SAN JUAN WATERSHED PROJECT

Final Environmental Impact Report
State Clearinghouse No. 2016121001

Prepared for
Santa Margarita Water District

Prepared by
Environmental Science Associates

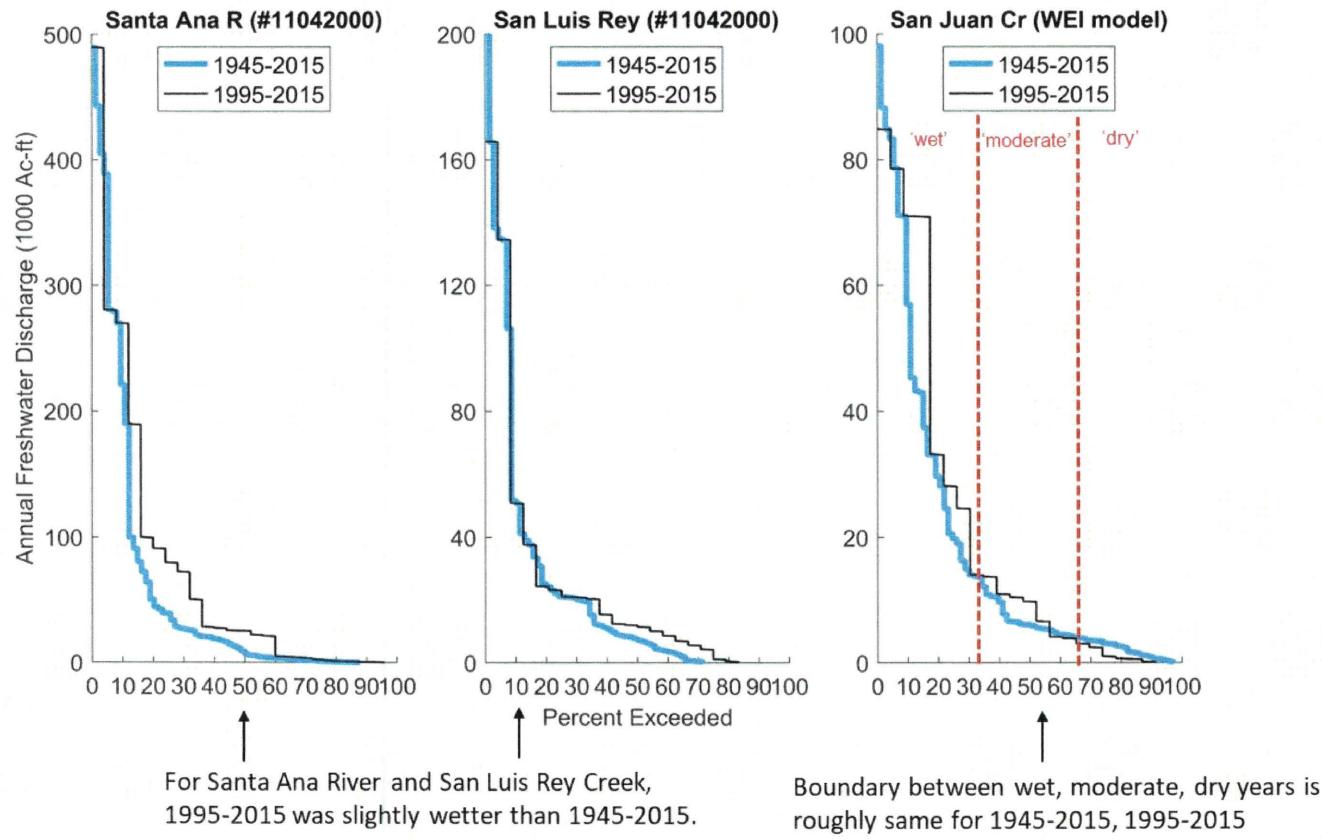
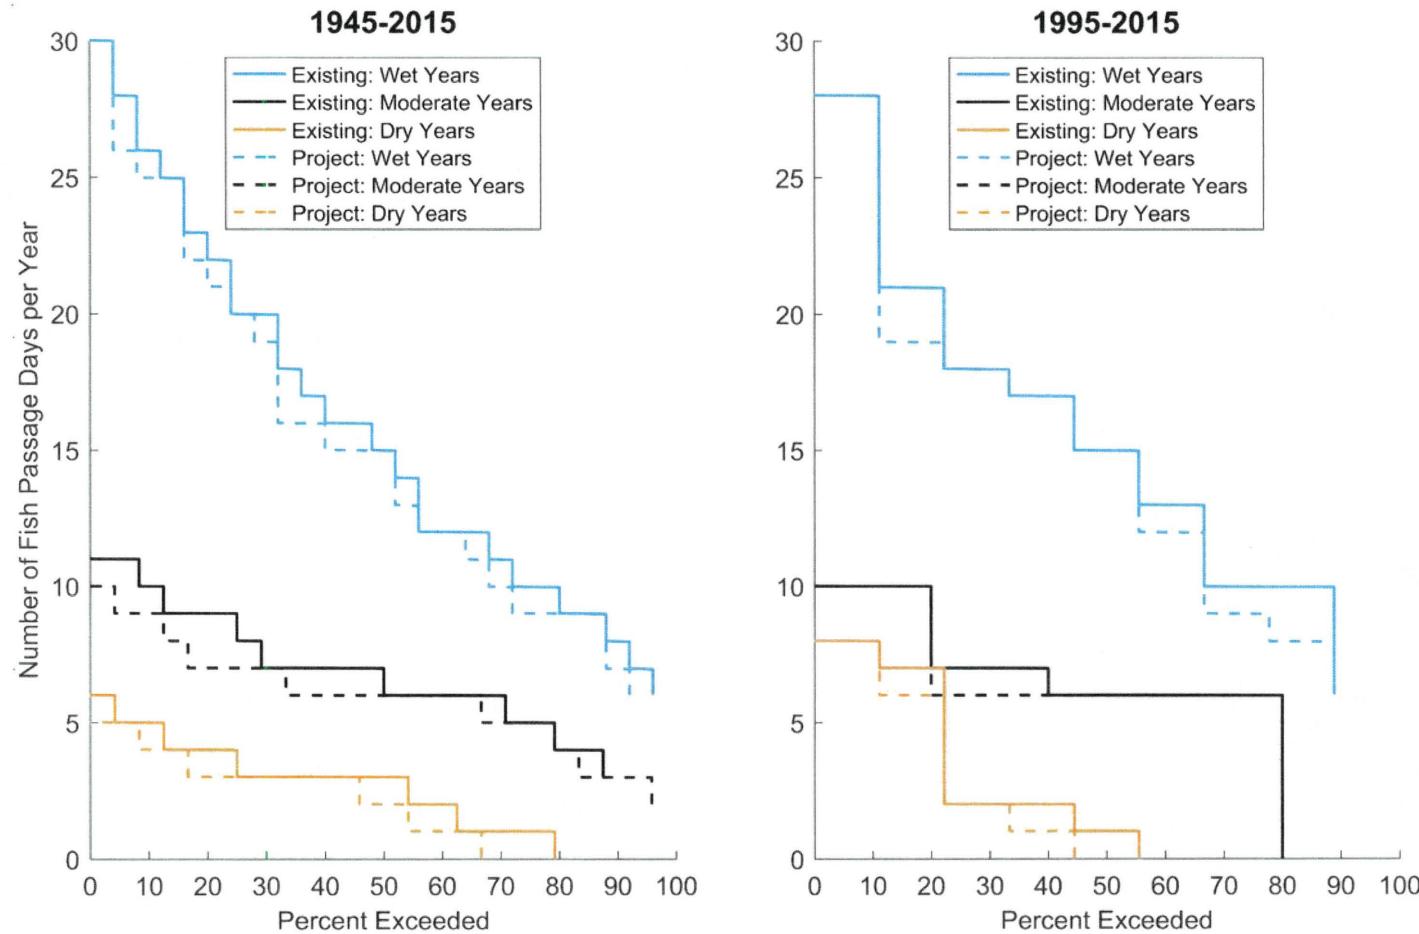
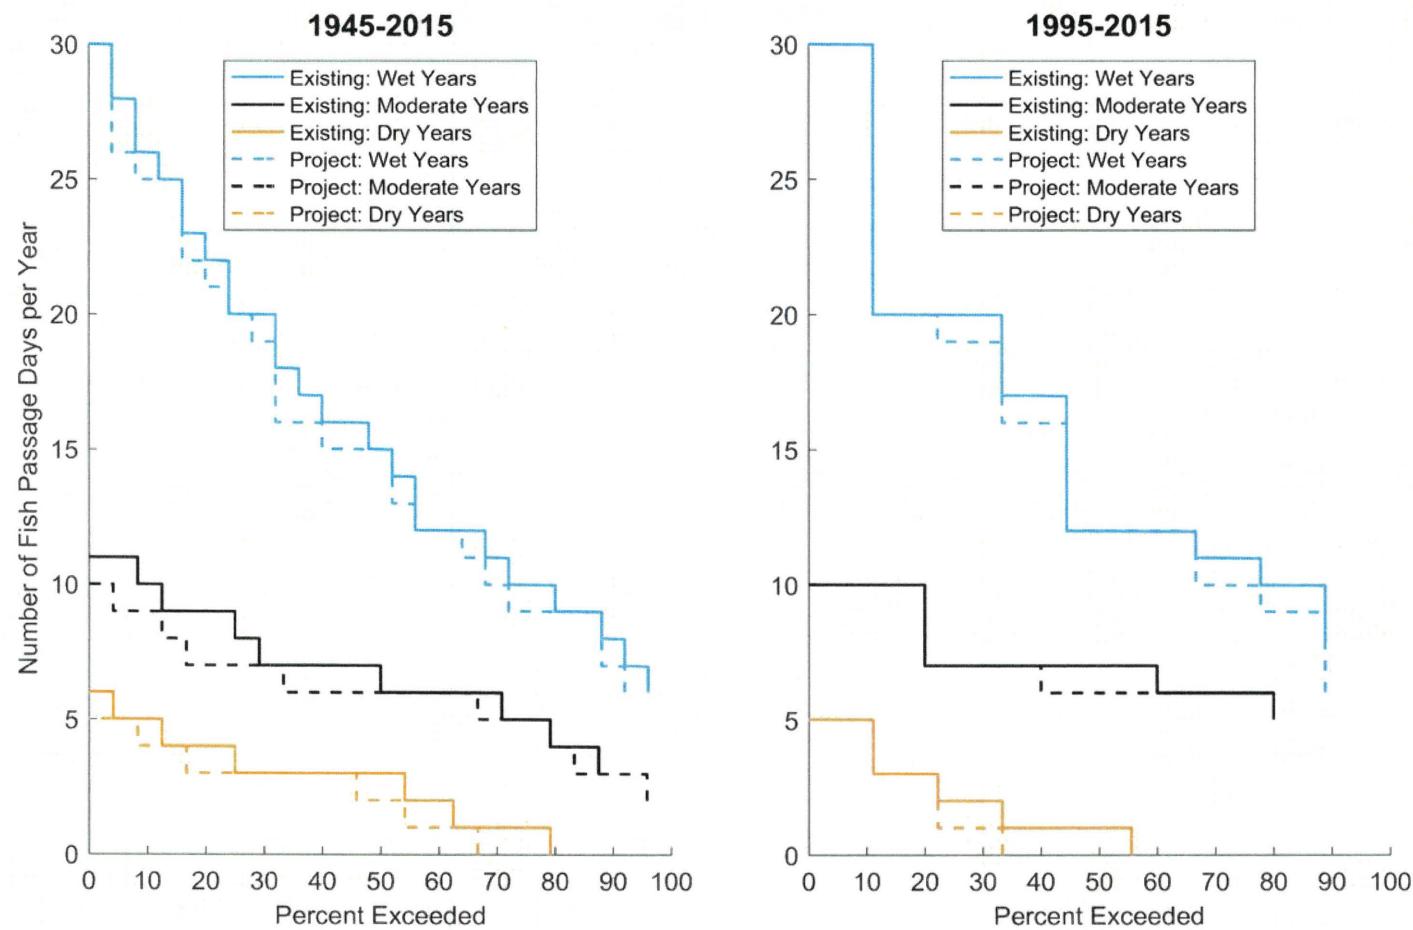
Finally, passage days for steelhead are based on applying flows over a fixed bed; whereas the actual channel has a soft bottom. We expect channel topography will change seasonally and annually in response to the number and magnitude of precipitation events. Therefore, it is important to understand when the topographic data was collected, relative to the expected timing of steelhead migration and how the channel topography changes over time.

In response to comments, ESA subdivided the 1945-2015 time series of daily flows provided by WEI into ‘wet’, ‘moderate’, and ‘dry’ conditions. Figure 1 shows exceedance curves of total runoff in San Juan Creek for 1945-2015 and for 1995-2015, and shows the divisions made to bracket years into each different wetness type. Years where flow was at or below the lowest 33 percentile for total flow were classified as ‘dry’; years between the 33rd and 67th percentile flow were classified as ‘moderate’ and years where flow was above the 67th percentile were classified as ‘wet’. For comparison, Figure 1 also shows the runoff conditions at two nearby gauged sites for the same time periods. Overall, the most recent 20 years has a similar range of year types as the full time series, so running the analysis for just the last 20 years would not greatly change the results in terms of days per year that various conditions were met or not met.

Figures 2 and 3 show exceedance curves for the number of days of fish passage on San Juan and Trabuco Creeks. The number of fish passage days is subdivided by time series (1945-2015 or 1995-2015), and by year wetness type. As expected, wetter years have more fish passage days (mouth of the lagoon more frequently open) than ‘moderate’ or ‘dry’ years under both existing and project conditions, and the project results in a slightly smaller number of fish passage days compared to existing conditions, as has been discussed in ESA’s prior report.
